This study evaluates the performance of reanalysis, regional mesoscale simulations, and purpose built wind datasets in a promising yet sparsely observed offshore environment near Hawaii. Using a year-long lidar buoy deployment off the eastern coast of Oahu, it characterizes the local wind resource and validates four datasets (ERA5, UH-WRF, NOW-23, GWA3) at different spatial resolutions. The region's persistent trade winds make it favorable for wind power, but limited hub height observations underscore the need for accurate data. By comparing multiple products in this uniquely characterized setting, the work is relevant to the sector and appears suitable for publication pending the revisions below.

We are deeply grateful for your time and thoughtfulness in reviewing our manuscript and providing valuable suggestions for improvement. We are thankful for the opportunity to share an updated draft that reflects the guidance provided by yourself and an additional reviewer.

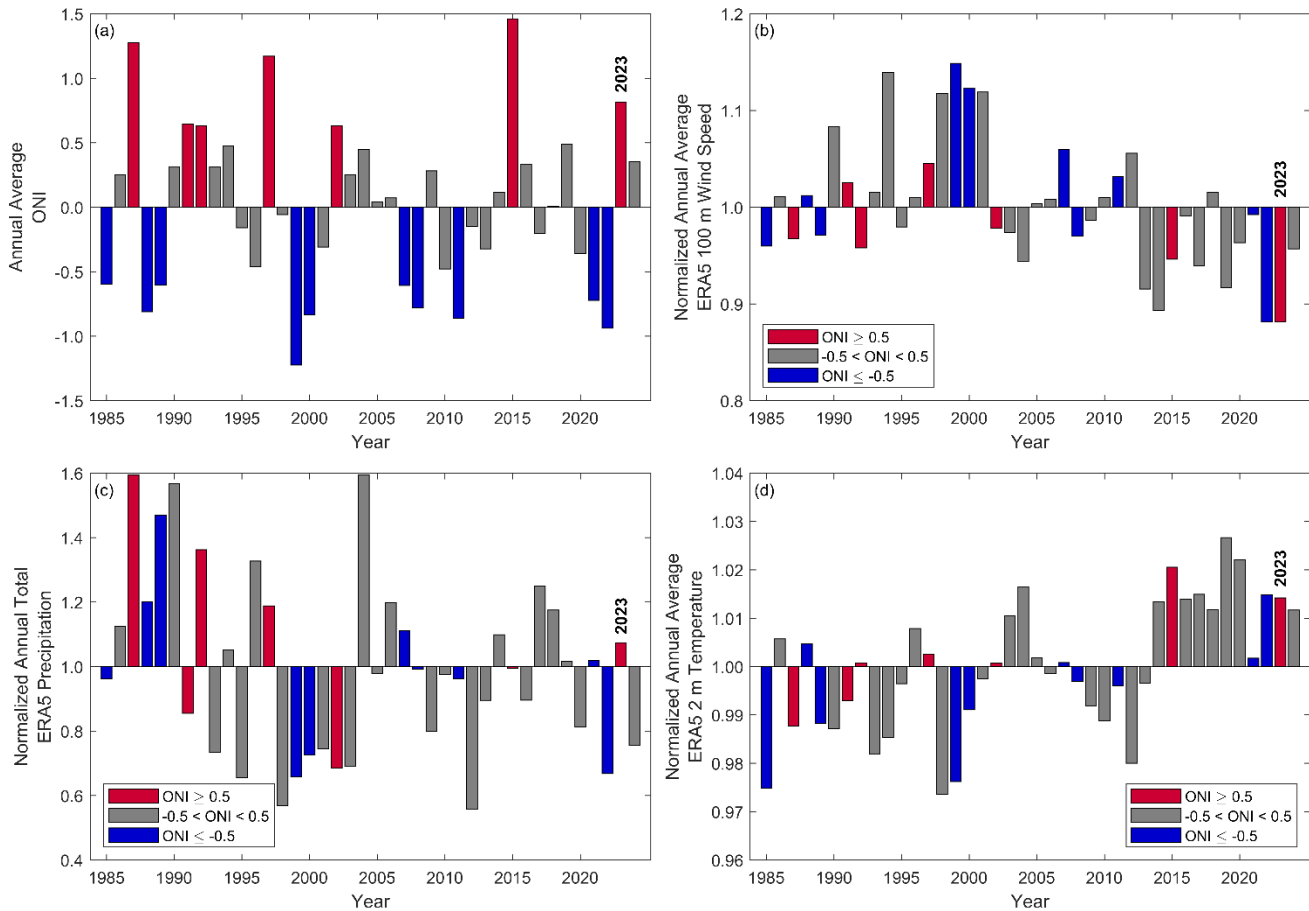
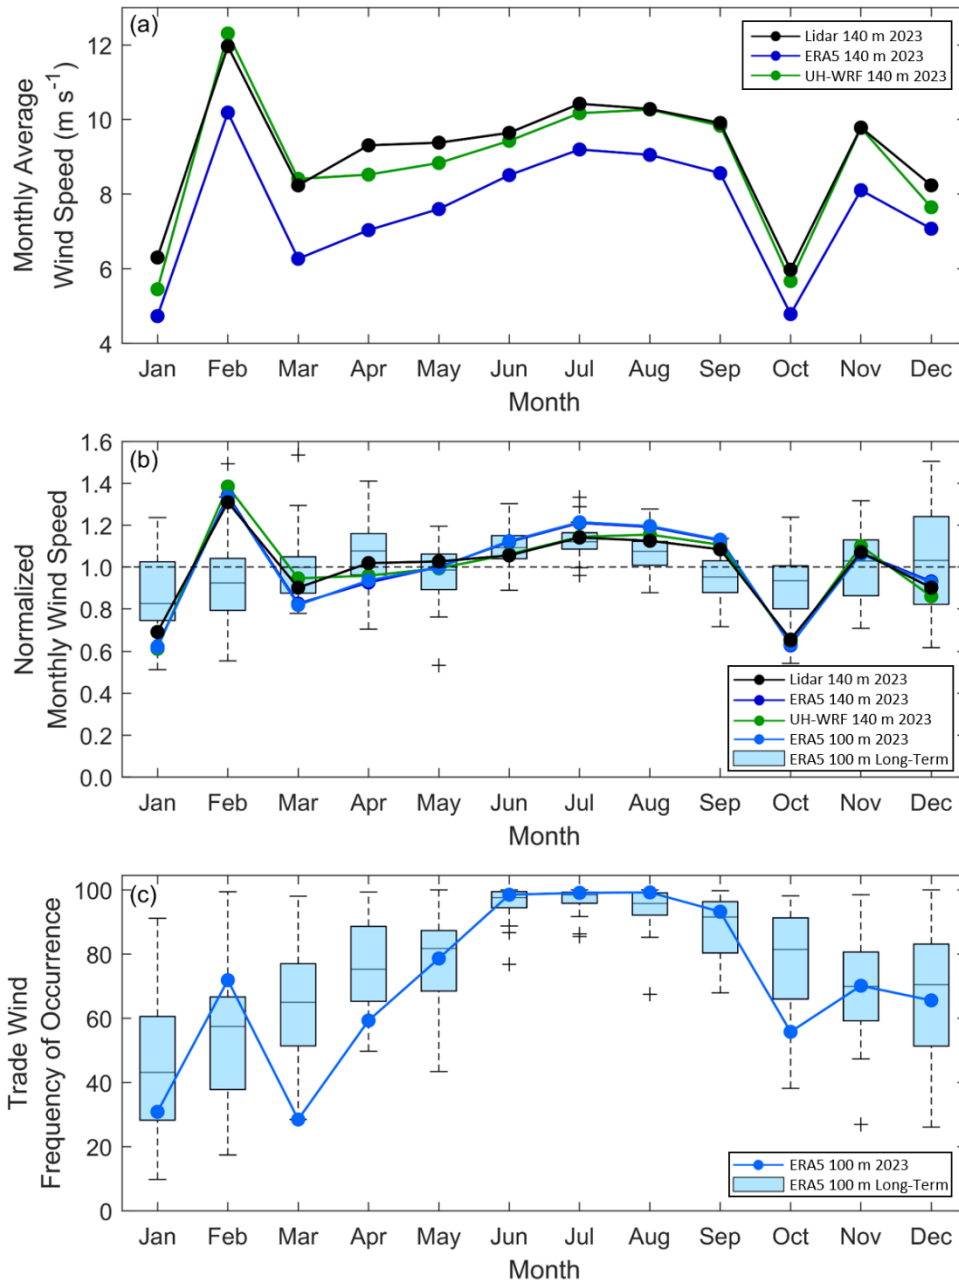
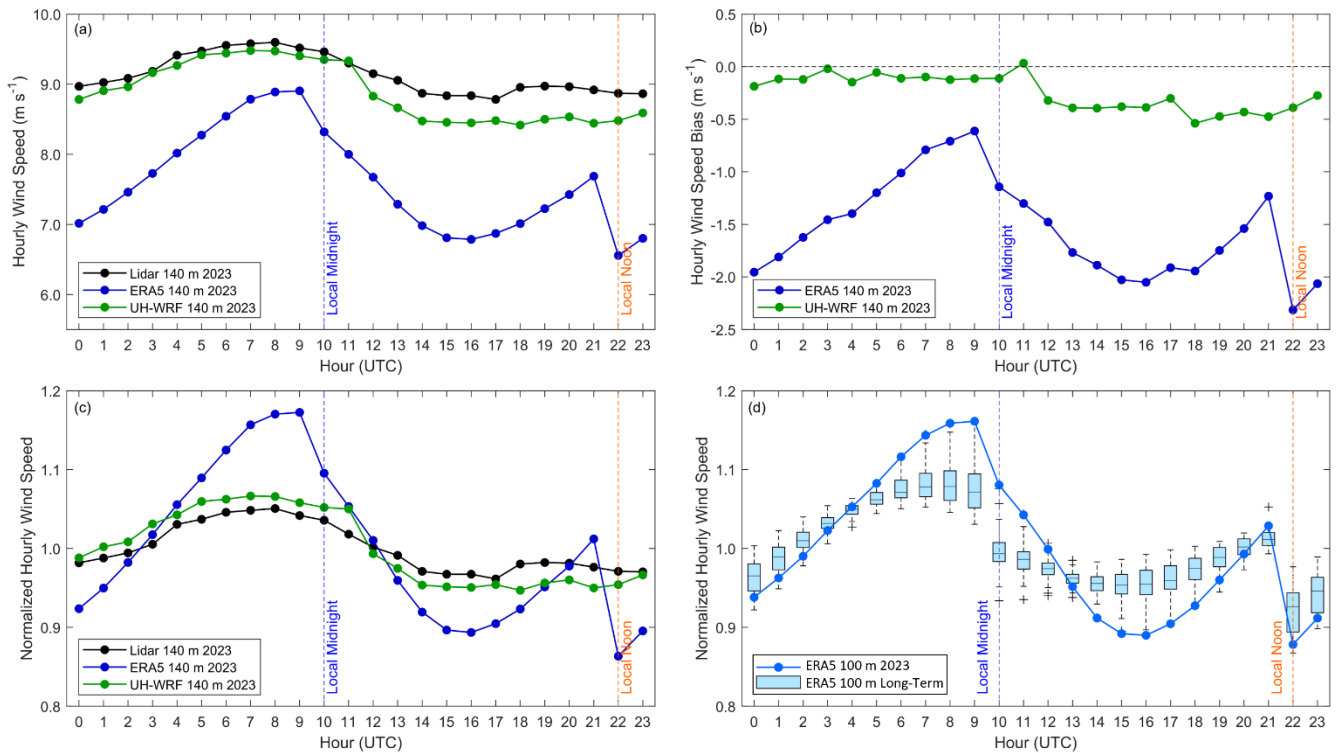
L437–438: The winds may be consistent, but was 2023 a regular year? Maybe it would be helpful to include this information. Also, what is the distance from the buoy to the nearest coastline? If the ERA5 grid cell includes or lies close to the coast, this proximity could influence the results.

As for whether 2023 was a regular year, both you and Reviewer 1 asked this important question, which refocused the analysis of this manuscript to validating only the concurrent simulations, ERA5 and UH-WRF. Your suggested evaluation revealed that 2023 was not a typical year for wind resource off the east coast of O’ahu. We have added the following context to Lines 180-194 per your helpful recommendation:

“Prior to comparing the O’ahu observations, which predominantly occur in the year 2023, with atmospheric datasets, it is imperative to provide context on what kind of meteorological year 2023 is relative to the long-term interannual wind speed variability noted at the deployment location. Utilising annual averages of the Oceanic Niño Index (ONI), we find that 2023 is categorized as an El Niño year based on the Climate Prediction Center’s threshold of $\pm 0.5^{\circ}\text{C}$ (Figure 3a) (NOAA, 2025). In Figure 3b, we explore the annual average ERA5 100 m wind speeds (CDS, 2025b) between 1985 and 2024 and determine that 2022 and 2023 are tied for having the lowest annual average wind speeds over the 40-year period (annual average wind speeds normalized by the 40-year mean for both years = 0.88) while being opposingly classified as La Niña and El Niño years, respectively (Figure 3a). According to ERA5, precipitation and 2 m temperature are above average at the buoy location for the year 2023 (Figure 3c, d). The above average precipitation, temperature, and weakening of the trade winds are consistent with expected El Niño characteristics (Lu et al., 2020).

The following analyses focus on the performance of two simulation datasets that have concurrent temporal coverage with the 2023 observations: ERA5 and UH-WRF. Given the context of 2023 being a record low wind resource year east of O’ahu according to the ERA5 record, it is important to note the need for long-term, continuously updating datasets like reanalyses. Purpose-built wind datasets, like NOW-23 (2000-2019) and Global Wind Atlas (2008-2017), provide numerous years for wind resource assessment but would not represent the characteristics of an atypical year like 2023.”

The 2023 seasonal and diurnal wind speed variations were also atypical relative to 40 years of ERA5 data, and we have included the following text and figures to highlight this determination.

Lines 236-249: “Looking at the monthly wind speeds normalized by the annual average wind speed from the 2023 deployment observations and the simulation datasets, which show similar patterns, in the context of 40 years (1985 to 2024) of normalized monthly 100 m wind speeds from ERA5 (CDS, 2025b), the 2023 seasonal wind speed cycle is atypical relative to the long-term (Figure 6b). While weather events can occur along the eastern shores of O’ahu that alter the typical conditions (Morrison and Businger, 2001) and potentially the temporal wind speed patterns (see Section 3.7), long-term ERA5-based analysis indicates that the 2023 seasonal wind speed cycle at the buoy location is driven by the prevalence of the trade winds (Figure 6c). We find that faster (slower) monthly average wind speeds in 2023, relative to the long-term trends, follow a pattern of increased (decreased) frequency of occurrence of the trade winds (Figure 6b, c). For example, the average wind speed at the buoy location during February 2023 is the 96th percentile of the averages for all Februarys in the 40-year ERA5 record. The frequency of occurrence of the trade winds (50°-100°) during February 2023 (occurring 72% of the time) corresponds to a high percentile relative to all Februarys in the 40-year ERA5 record: 87th. Similarly, the slowest monthly wind speeds in 2023 relative to their 40-year counterparts (January: 9th percentile, March: 18th percentile, October: 4th percentile) have lower frequencies of trade wind occurrences during 2023 (January: 29th percentile, March: 1st percentile, October: 7th percentile) (Figure 6b, c).”

Lines 276-277: “As with the annual and seasonal wind resource, 2023 is an atypical year relative to 40 years of ERA5 diurnal cycles (Figure 7d).”

Figure 12. (a) Estimated cloud optical thickness based on pyranometer measurements from the lidar buoy deployment. (b) Observed 140 m wind speed, (c) ERA5 140 m wind speed bias, and (d) UH-WRF 140 m wind speed bias according to clear versus cloudy sky conditions.

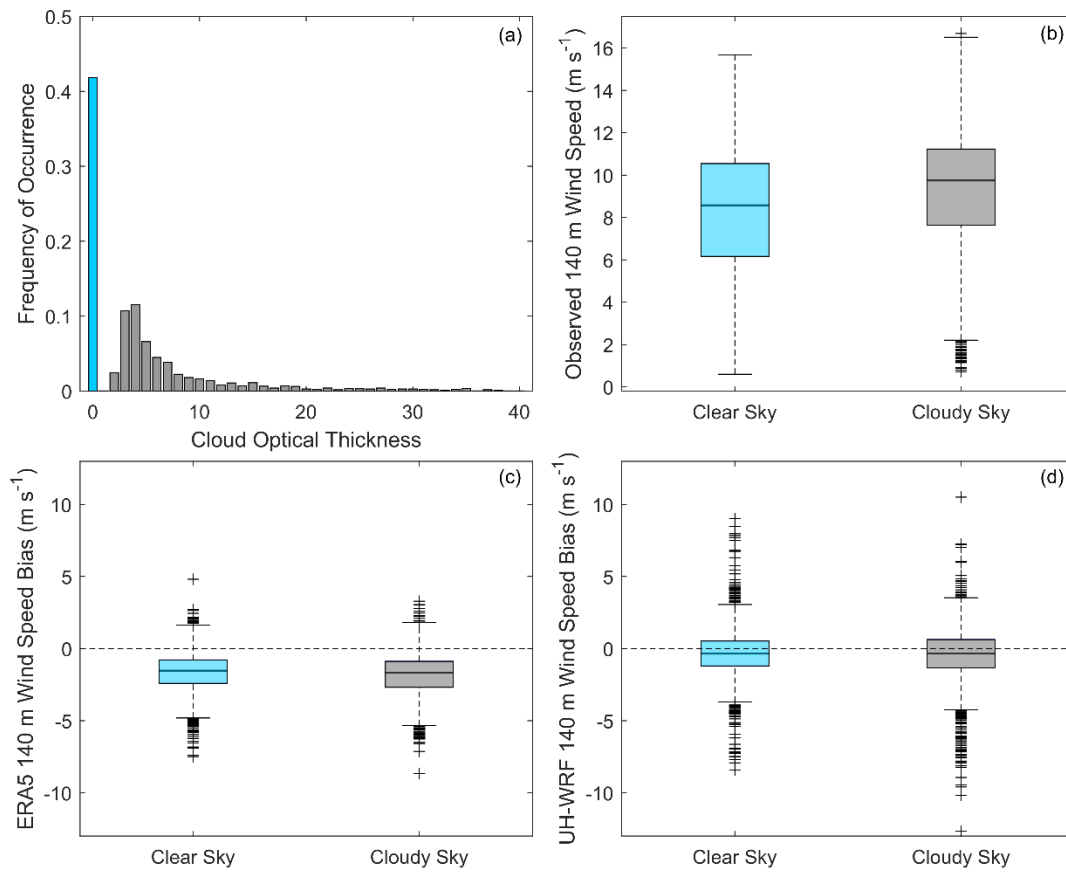
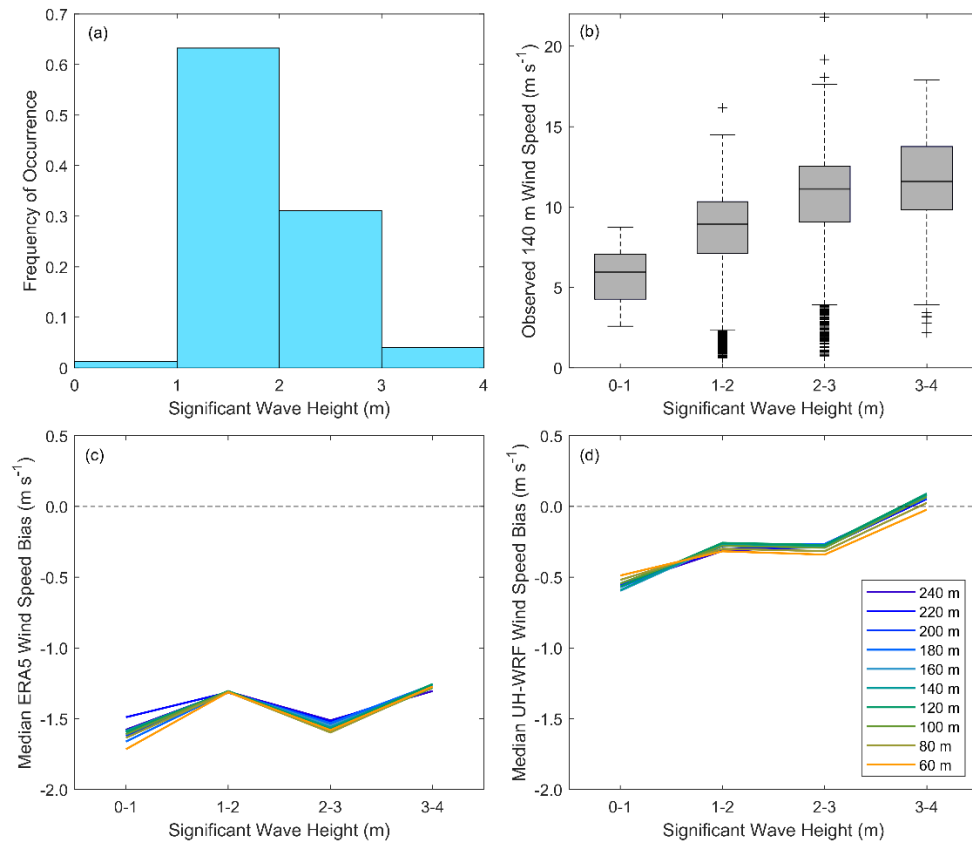
Appendix A3.3 and A3.4: Consider removing if not essential to understanding the manuscript.

Based on your helpful suggestion here, we recognized that we were not utilizing the buoy observations to their full potential to characterize the performance of ERA5 and UH-WRF. As clouds and waves are both important influences on offshore wind profiles, we have added Sections 3.5 (Wind dataset performance according to cloud conditions) and 3.6 (Wind dataset performance according to ocean conditions) to the main body of the manuscript.

“3.5 Wind dataset performance according to cloud conditions

The presence of clouds, and the ability of simulation datasets to account for them, can impact the accuracy of wind speed estimates. For example, Lee et al. (2025) find that rotor layer wind speeds at two locations offshore of California, United States are generally stronger under clear sky conditions and that the High-Resolution Rapid Refresh model exhibits a smaller bias under cloudy conditions. During the O’ahu deployment, the lidar buoy was equipped with a pyranometer that allows for estimation of the cloud mask and cloud optical thickness (Appendix A3.4) (DOE, 2025b). A pyranometer outage occurred between 10 January and 17 March 2023 (DOE, 2025b). Of the period when the wind speed and pyranometer observations, along with the ERA5 and UH-WRF simulations, are available, 42% of the analysis period is characterized by clear sky conditions and 58% by cloudy conditions (Figure 12a). When comparing clear versus cloudy periods, we find the opposite results of Lee et al. (2025): the O’ahu 140 m observed wind speeds are generally stronger during cloudy periods (median = 9.75 m s^{-1}) than during clear sky periods (median = 8.57 m s^{-1}) (Figure 12b). This is primarily due to the presence of stratocumulus cloud conditions over California, which generally suppress turbulence and vertical mixing, reducing wind speeds, in contrast to trade wind cumulus clouds near Hawai’i, which are associated with stronger winds and increased convection. At the O’ahu location, ERA5 performs slightly worse during cloudy conditions in representing the observed 140 m wind speeds (median bias = -1.52 m s^{-1} for clear sky periods versus -1.69 m s^{-1} for cloudy periods), whereas UH-WRF performs similarly regardless of the presence of clouds (median bias = -0.35 m s^{-1} for clear sky periods versus -0.33 m s^{-1} for cloudy periods) (Figure 12c, d).”

“3.6 Wind dataset performance according to ocean conditions

Over bodies of water, wave fields impact surface momentum fluxes and therefore wind speed profiles (Edson et al., 2013). While some exploratory research has been performed to evaluate the role of wind/wave interactions on wind profiles, most predictive models used for wind resource assessment do not predict the wave fields, instead relying on parameterizations to represent their effects (Gaudet et al., 2022; 2024). Wave measurement at the lidar buoy location begins 17 March 2023 and continues uninterrupted through the remainder of the deployment (Appendix A3.3). During the overlapping period of the wind and wave observations and the ERA5 and UH-WRF simulations, significant wave heights between 1 m and 2 m occur most frequently (63% of the period) (Figure 13a). A positive correlation is noted between observed significant wave height and the 140 m wind speed, though the weakest wind speeds occur when the significant wave heights meet or exceed 1 m (Figure 13b).

Regardless of lidar measurement height, no trends in the ERA5 wind speed performance emerge according to significant wave height, with median ERA5 wind speed biases of -1.72 m s^{-1} , -1.31 m s^{-1} , -1.58 m s^{-1} , and -1.27 m s^{-1} at the closest lidar height to the surface (60 m) corresponding to significant wave heights of 0-1 m, 1-2 m, 2-3 m, and 3-4 m (Figure 13c). At all lidar measurement heights, the UH-WRF wind speed biases become increasingly positive with increasing wave height, with median wind speed biases at 60 m of -0.49 m s^{-1} , -0.32 m s^{-1} , -0.34 m s^{-1} , and -0.02 m s^{-1} corresponding to significant wave heights of 0-1 m, 1-2 m, 2-3 m, and 3-4 m (Figure 13d).”
